# Groundwater Transfer Review Summary Form

Transfer/PA # T- 14828

Application: T-14828

Applicant Name: Roger Nicholson / Agri-Water LLC

**POA Hydrograph**

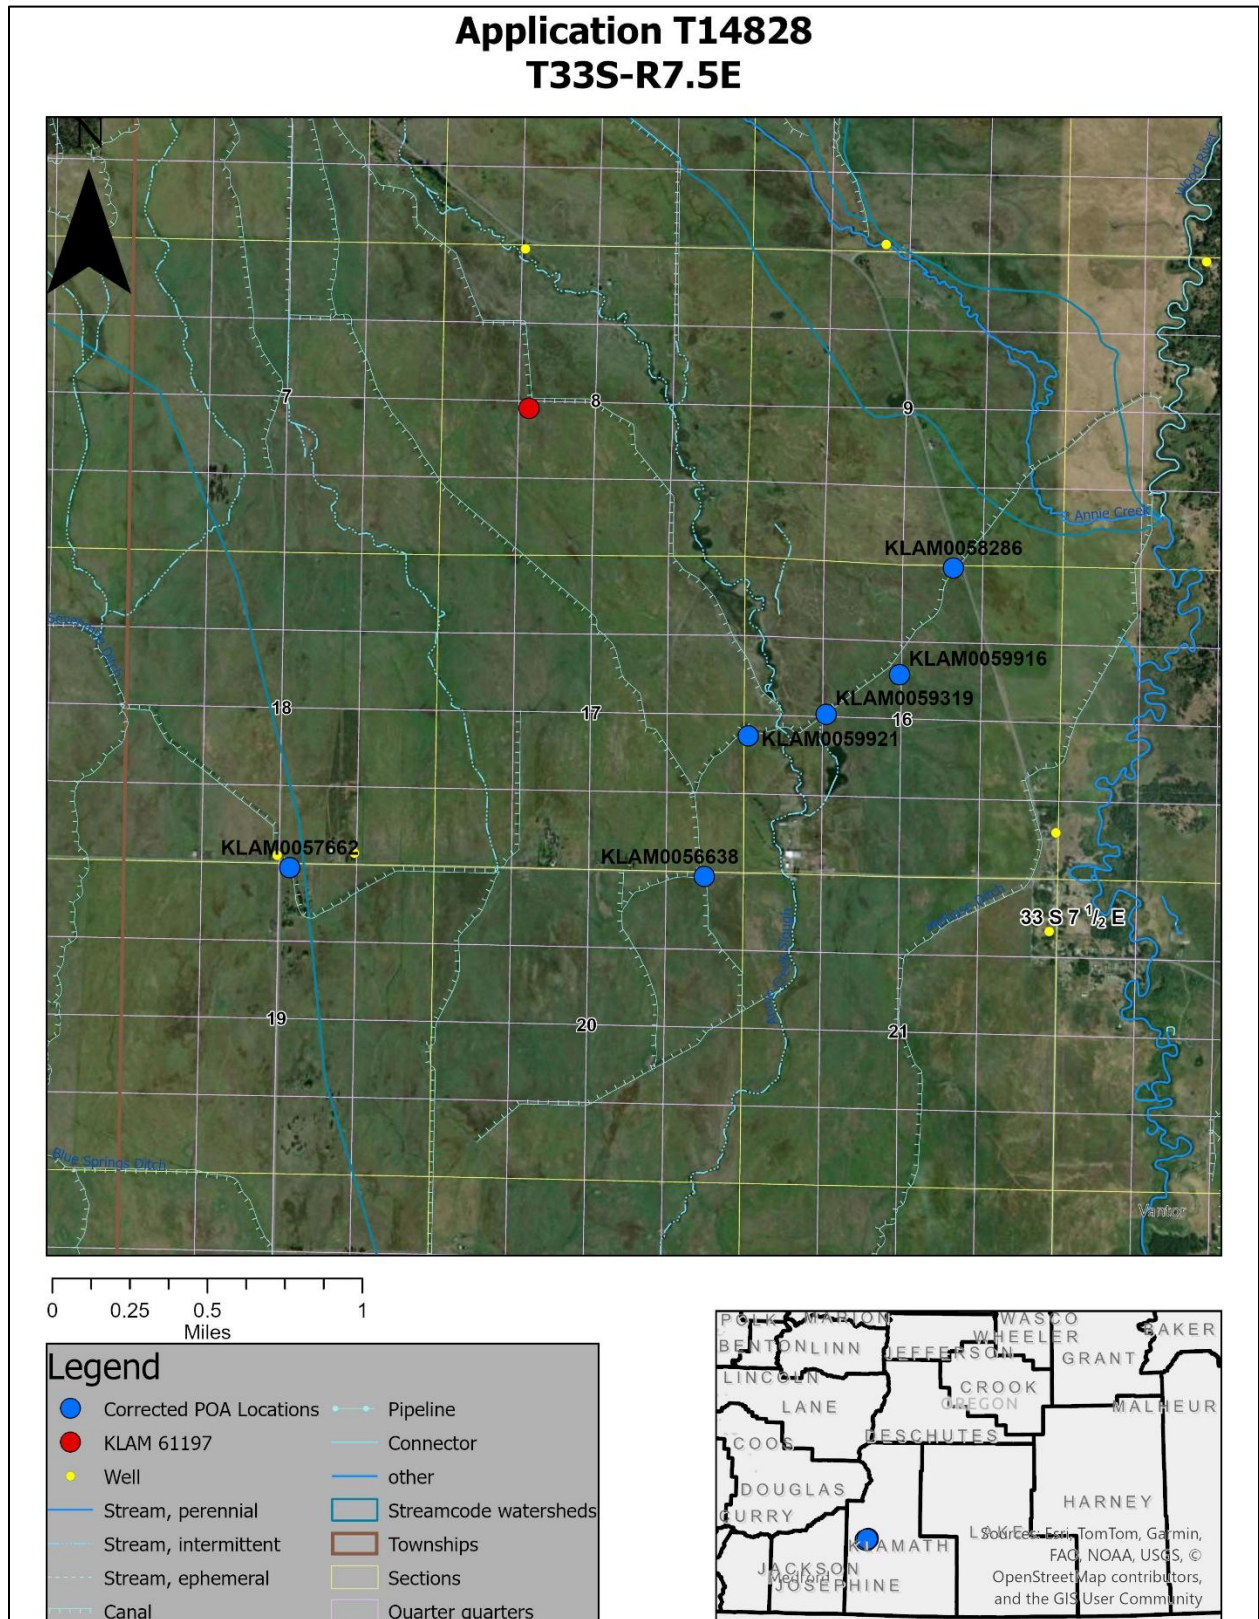
A hydrograph showing all measurements for each POA is included as a figure at the end of the document. To date, none of the POAs have triggered their decline conditions. Below is a table of each POA, reference level and associated measurement date.
